Value Engineering Study

KY338 RECONSTRUCTION PROJECT AT I-71/I-75 BOONE COUNTY, KENTUCKY

VE STUDY NUMBER 201206

Draft Report

VALUE ENGINEERING DESIGN COMMENT # VE-1

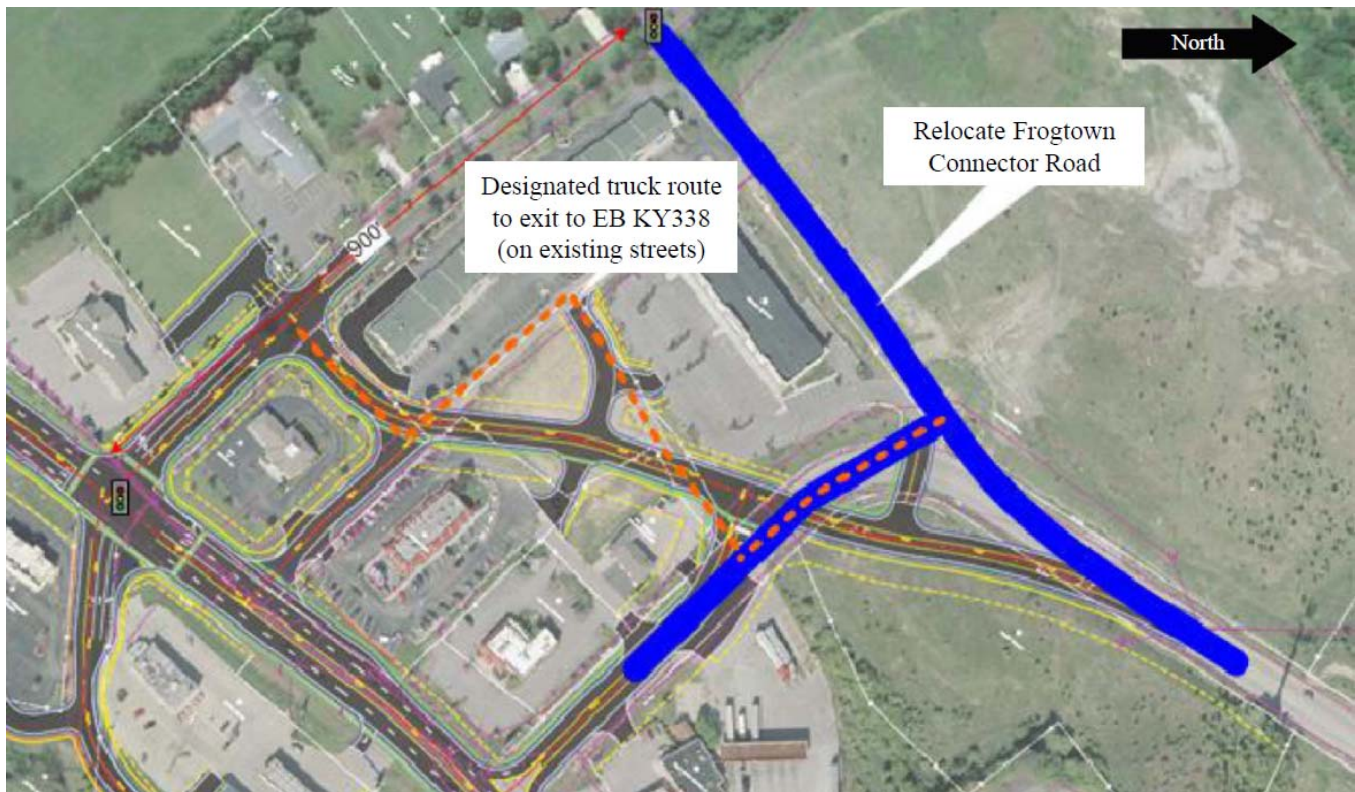
Relocate Frogtown Connector to meet Paddock Drive to just north of the strip mall in lieu of connecting south of the strip mall.

There is concern that during the peak hours there will be long queues on Paddock Drive waiting to turn left, thus causing traffic operational problems at the proposed intersection of Paddock Drive and relocated Frogtown Connector Road. As proposed, there is only 250 feet of space between the two intersections. To help avoid future queuing conflicts, Frogtown Connector Road can be connected to Paddock Drive on the opposite side of the shopping center, approximately 900 feet from KY338.

To accommodate trucks and avoid trucks running through the residential area, upgrades to the existing access road system can be made. This would entail reworking the radii of corners to account for needed tracking during turns. An alternate to this would be to send the trucks back to KY338 and provide a U-turn location to the west, possibly with a roundabout at Triple Crown Boulevard.

VALUE ENGINEERING DESIGN COMMENT # VE-2

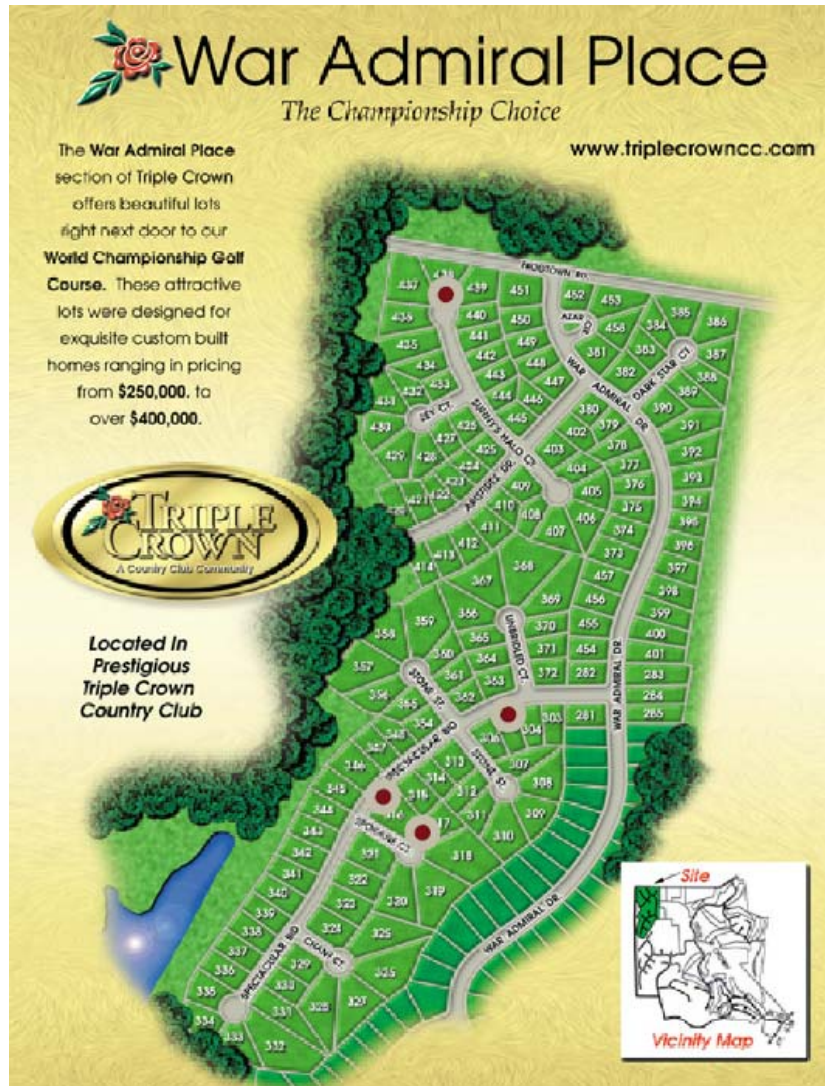
Reduce the number of lanes on Triple Crown Boulevard at KY338.

The proposed forecast for residential areas within Triple Crown, National Boulevard and Paddock Road assume a 2 percent annual growth rate to the design year. However, review of the existing subdivisions indicates that little developable land exists (e.g., Triple Crown currently has only 60 lots available for purchase). Utilizing the lower volumes to/from Triple Crown Boulevard may allow for acceptable operations without the need for the dual left turn lanes exiting Triple Crown. It is proposed that the existing entrance be maintained. However, the final design should accommodate future widening at the entrance if needed by providing proper alignment with a dual left turn lane from Triple Crown. This recommendation will reduce the amount of work on the landscaped entrance to Trip Crown and reducing construction costs. Furthermore, the single left turn egress from Triple Crown Boulevard will facilitate permitted left turn movements on the side streets, improving capacity and operations at the overall intersection.

VALUE ENGINEERING RECOMMENDATION # VE-3
SKETCH OF RECOMMENDED DESIGN

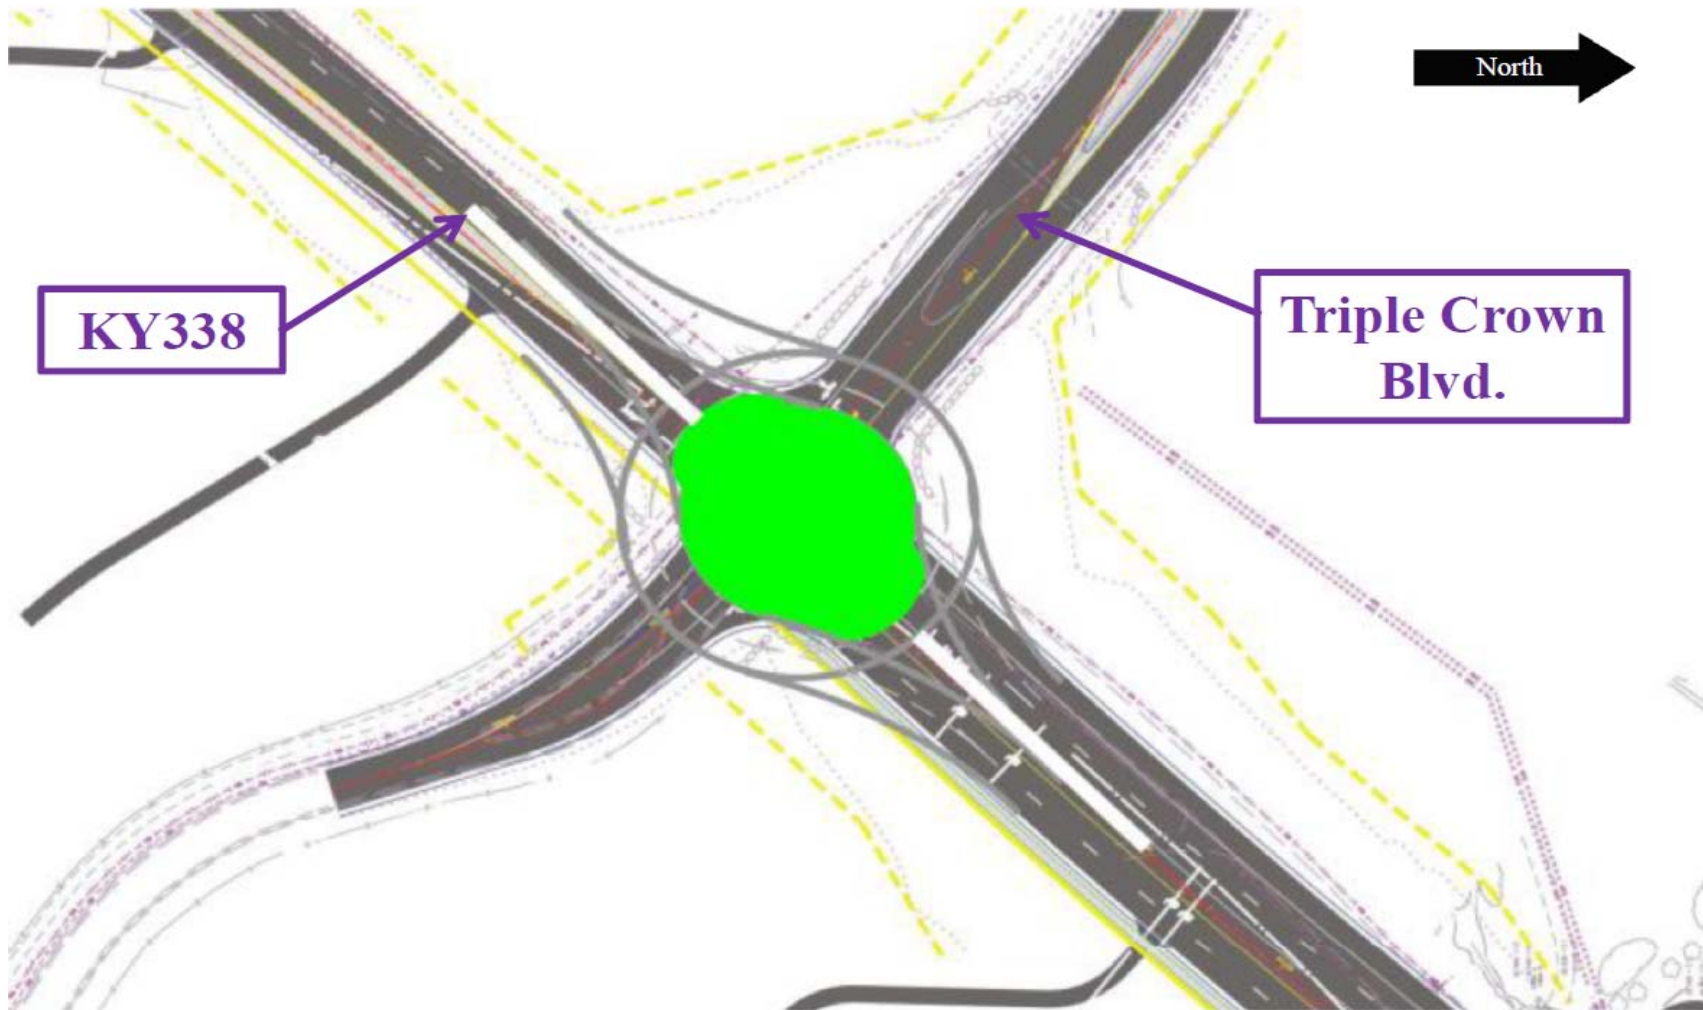
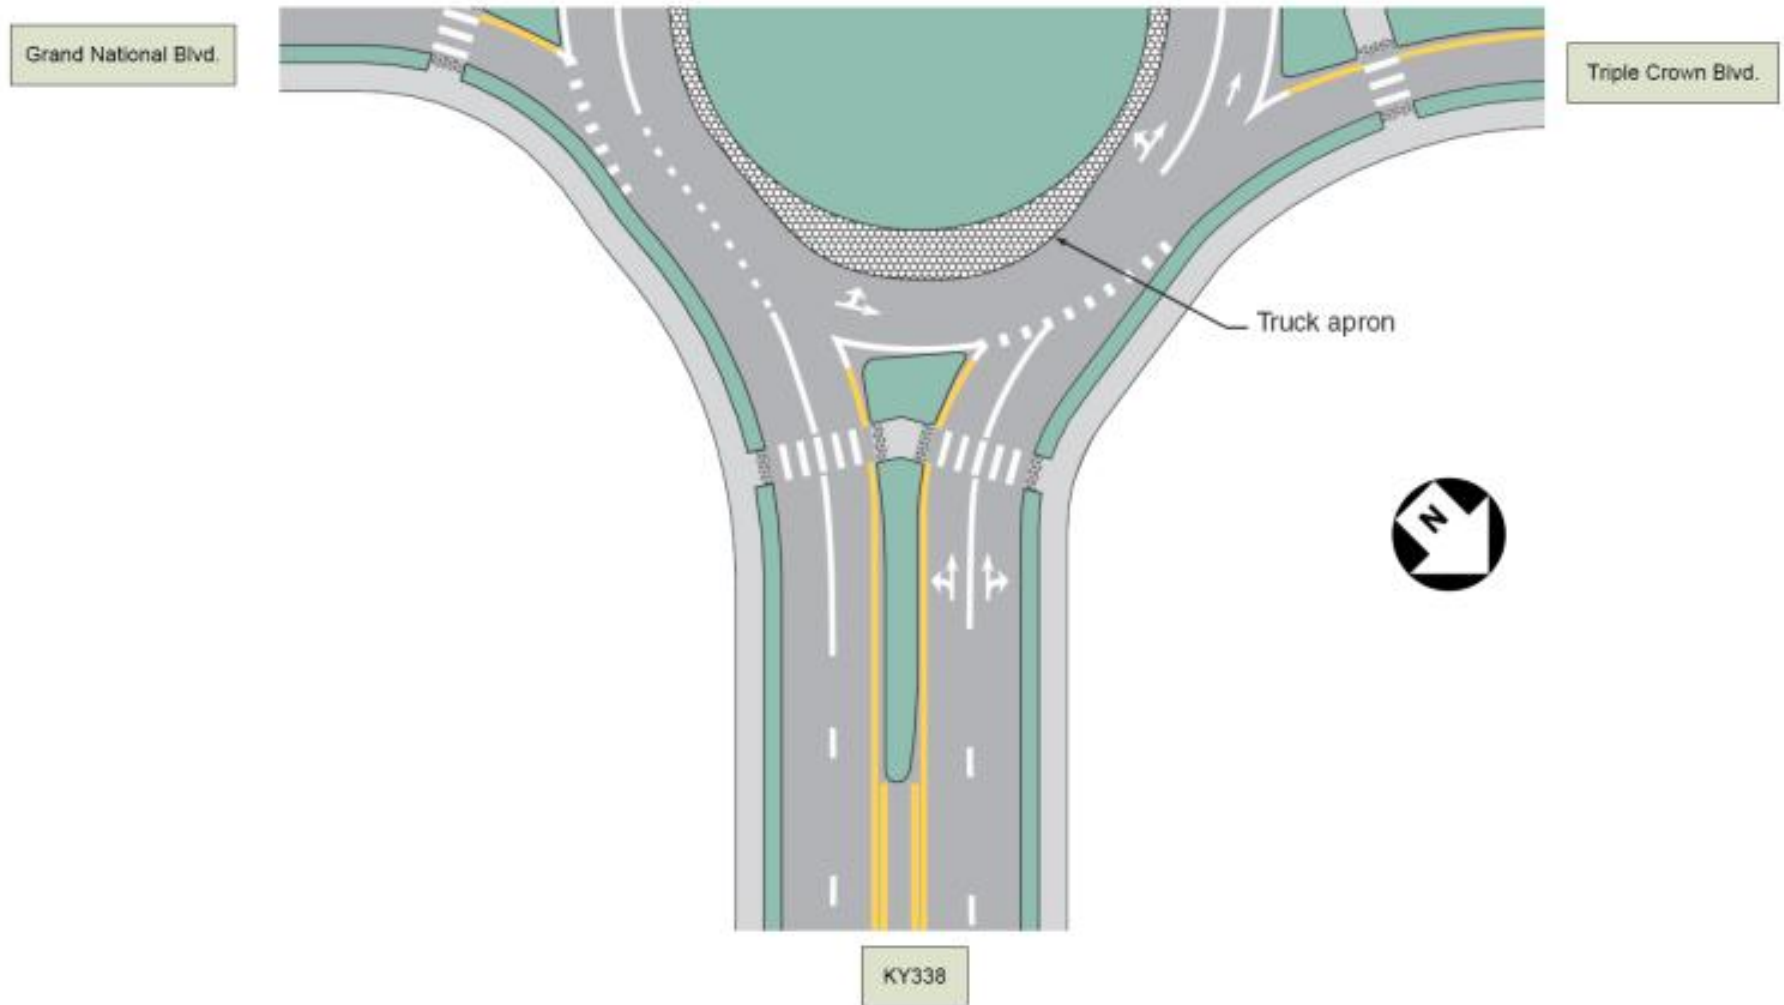
Construct a roundabout at KY338 and Triple Crown Boulevard in lieu of a new signalized intersection.

The original design specifies a signalized intersection at KY338 and Triple Crown Boulevard.

The VE Team explored the feasibility of this alternative using the Intersection Decision Analysis Tool (IDAT) developed by the Kentucky Transportation Center and FHWA CAP-X program. Analyzing using the 2030 volumes, both programs indicated that a roundabout is feasible during both AM and PM peak design hours. Using the HCM 2010, it appears that overall LOS is C. To accommodate the turning movements, two lane entries on the east and west legs would be needed and one lane entries on the south and north legs.

One advantage to the roundabout is that the transition from two lanes to one lane heading west could be accomplished in a shorter distance compared to the original design due to the exiting vehicular speed.

The VE Team recommends changing the intersection type to a roundabout.

VALUE ENGINEERING RECOMMENDATION # VE-4
SKETCH OF ORIGINAL DESIGN

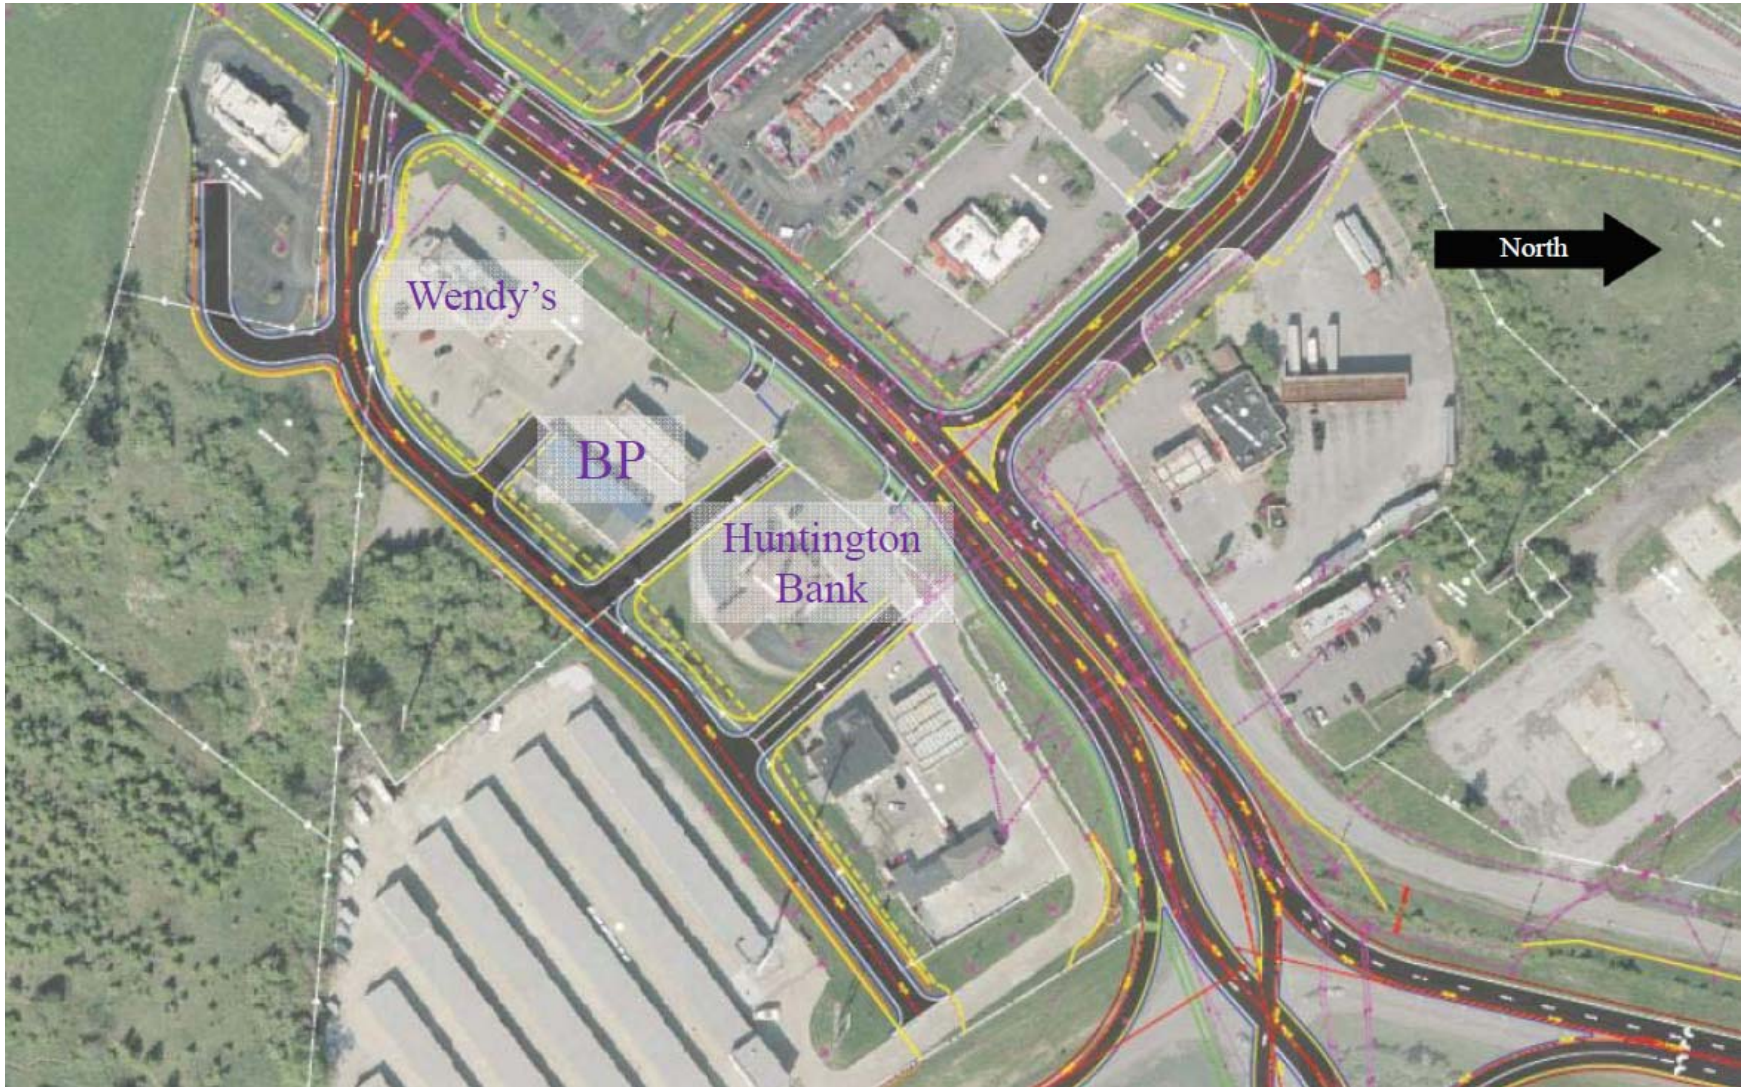
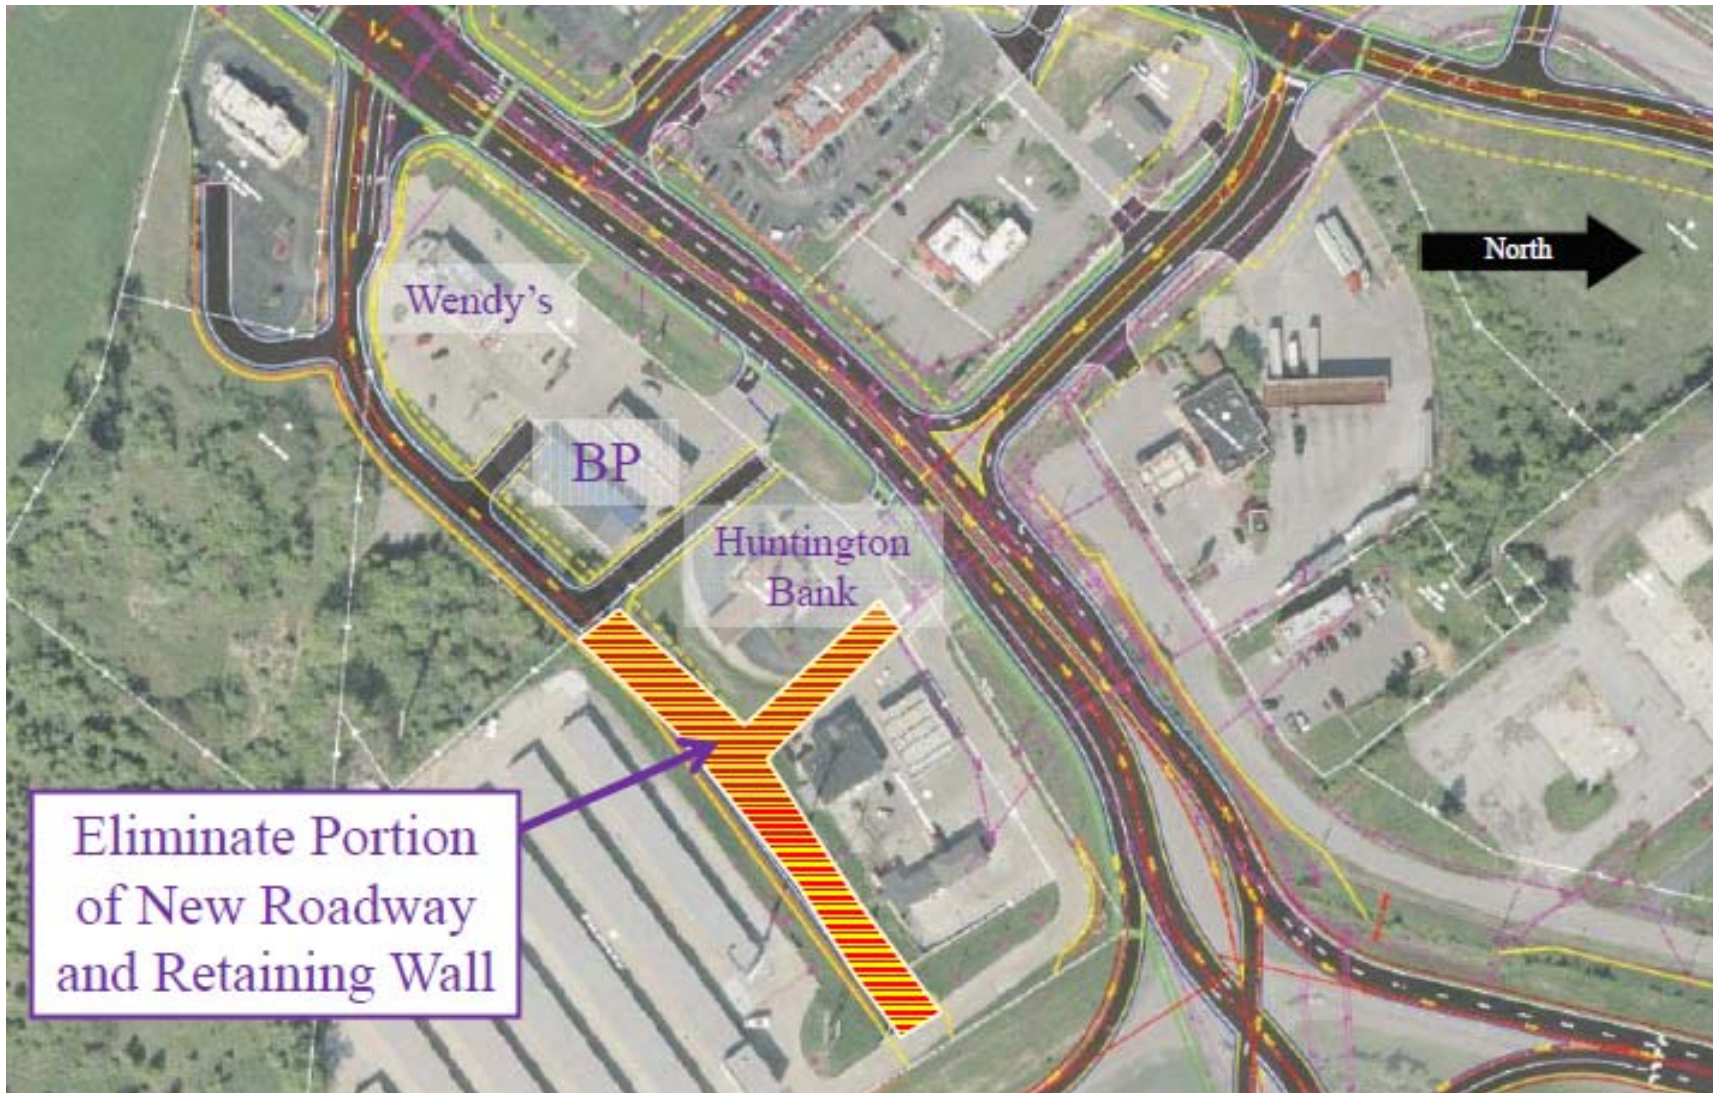
Terminate the backage road between the Huntington Bank and BP gas station in lieu of continuing road to the storage facility.

The original design in W-7 specifies a backage road providing access for the BP, Huntington Bank, Shell, Wendy's and storage unit on the south side of KY338. The backage road includes 3 access points, one in between each business, and extends to connect to the Smart Stop self-storage access road. Construction of the access road will require construction of approximately 900 feet of retaining wall to the east side of the access road.

The addition of the backage road requires an approximate 900 feet of retaining wall. By bringing the access road from behind the businesses to the front, the required retaining wall could be reduced to approximately 450 feet and will avoid constructing a wall adjacent to the existing Smart Stop self-storage facility.

The VE Team recommends bringing the access road to the front of the businesses in between the BP station and Huntington Bank, then continuing the access road in front of the Huntington Bank and Shell station, finally connecting to the existing road for Smart Stop.
